PJM-EDC WORKSHOP MEETING

6/14/21

JOINT EDC CORE PRINCIPLE

OVERIDE DISCUSSION

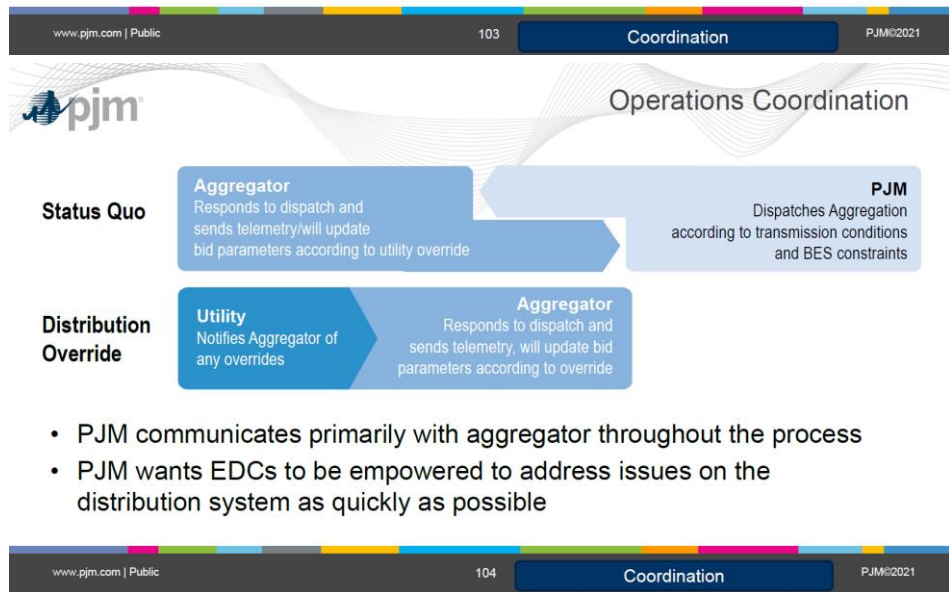
- Proposed EDC coordination slides are interpreted into meaning that the EDC only has the capability to perform post dispatch overrides.

Concerns

- Reliability and customer power quality need to take precedence over any market financial gain. In order to maintain this philosophy with FERC 2222, EDC's require override capabilities both before and after market dispatches are executed.

Thoughts

- Depending on the DERA dispatcher model, the EDC would either need to send the pre dispatch override to the DERA (DERA Dispatcher Model) or not execute the dispatch (EDC DER Dispatcher Model)
